A120.1 PUBLIC REVIEW DRAFT OCTOBER 2019

Proposed Revisions for ASME A120.1-20XX

*Safety Requirements for Powered Platforms and Traveling
Ladders and Gantries for Building Maintenance*

Revised Sketch for 3.5.1(c)

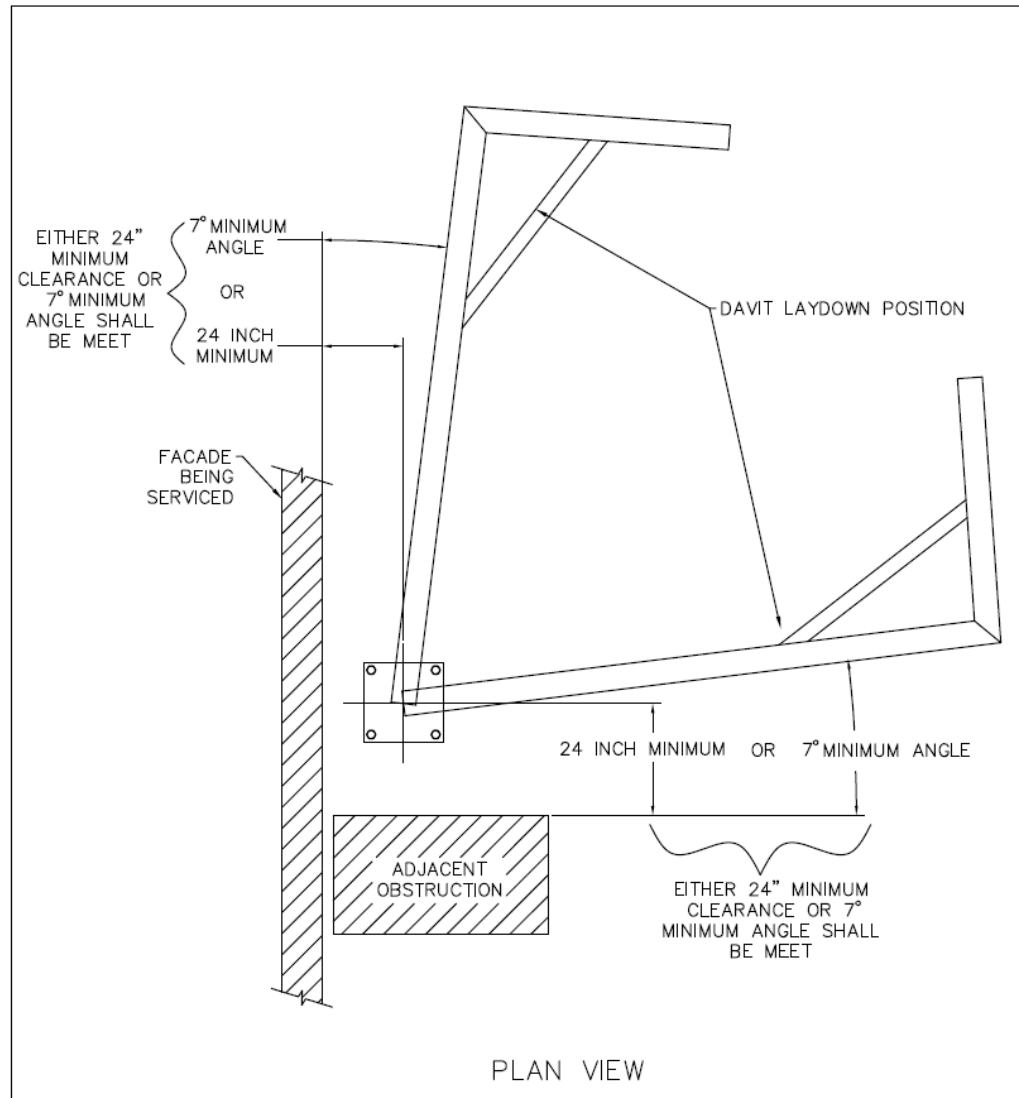
(3) shall have sockets positioned to prevent the davit from being raised not less than 7 deg with respect to the facade being serviced	(c) shall have sockets <u>or bases</u> positioned either a minimum of 24 inches from the parapet or adjacent obstruction or allow the davit to be raised <u>at a minimum angle of 7 degrees with respect to parapet or adjacent obstruction. (See sketch.)</u>	<i>Added or bases for clarification of nomenclature, reworded to minimum angle and added perspective for clarification.</i>
